GEOSHIELD Verification Report

PROJECT REFERENCE: GEO100209

PROJECT: Prologis Park

AREA SURVEYED: Lift Pits 3A and 3B

Lift Pit 3A

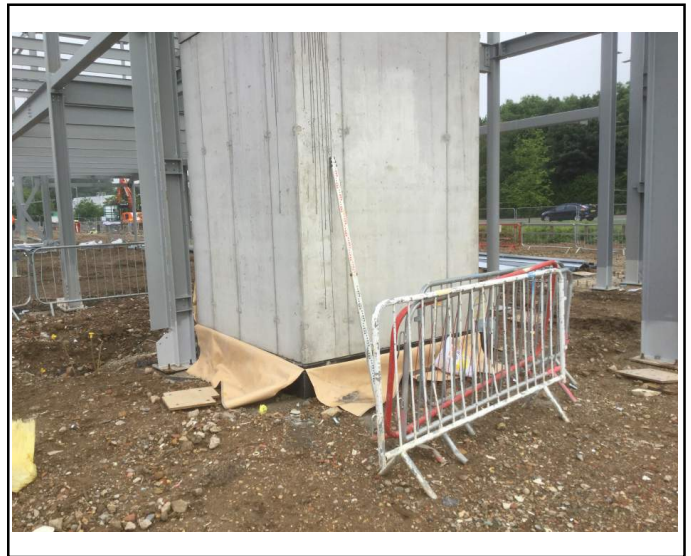
Lift Pit had been previously wrapped in

Monarflex Super as opposed to an appropriate Self Adhesive Gas Resistant Membrane

LOCATION/GRID LINE: Lift Pit 3A

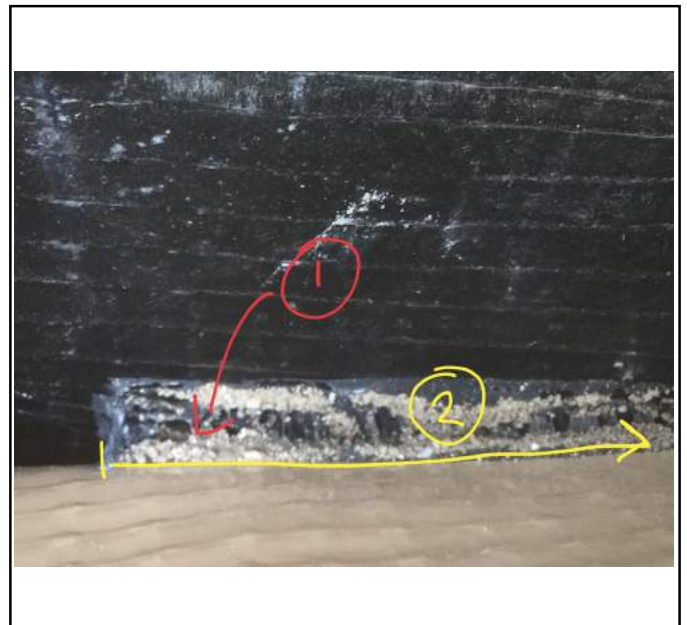
Photo 1 - showing the PAG Monarflex Reflex Super (1) being wrapped around the corner of the Lift Pit. This was typical to all four corners and therefore a complete seal at (2).

The PAG Monarflex Reflex Super was projected prior to backfilling with Protection Board.

LOCATION/GRID LINE: Lift Pit 3B

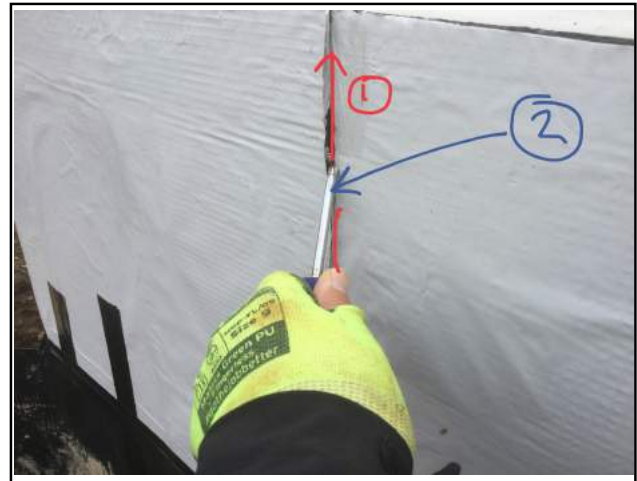
Photo 1 - showing the Pick & Probe Test (2) being undertaken along one of the four available GRSA Membrane Corner Lap Joints - all proved to be fully sealed

Photo 2 - showing the Pick & Probe Test being undertaken along a typical GRSA

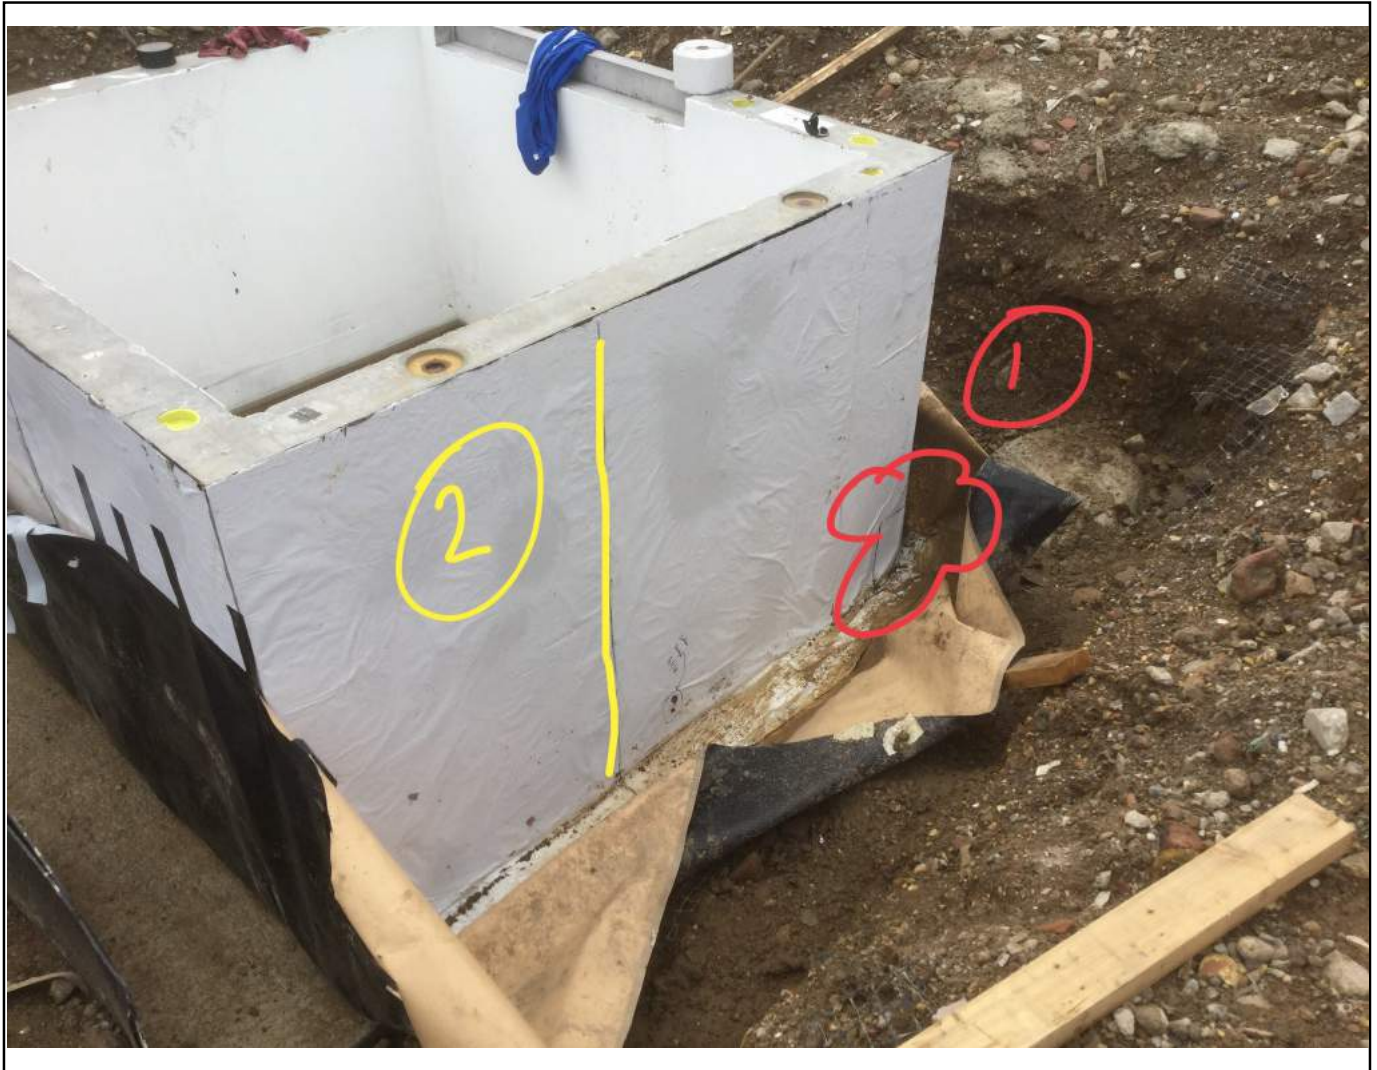
Membrane Lap Joints proving all had a good seal.

LOCATION/GRID LINE: Lift Pit 3B

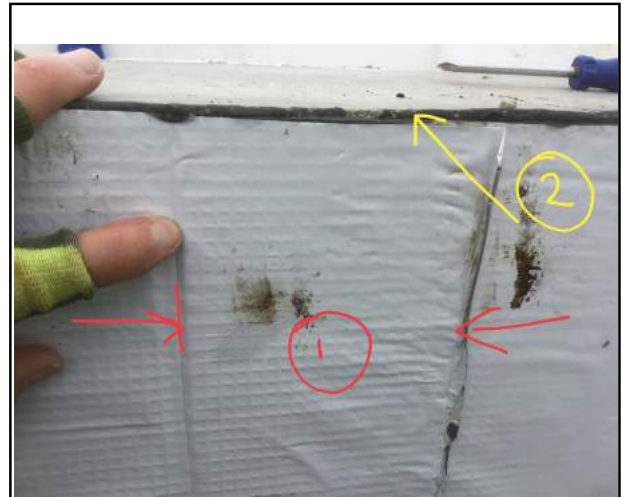
Photo 1 - showing the GRSA Membrane sealed (2) with the previously installed

PAG Monarflex Reflex Super (1) completely sealing the Lift Pit.
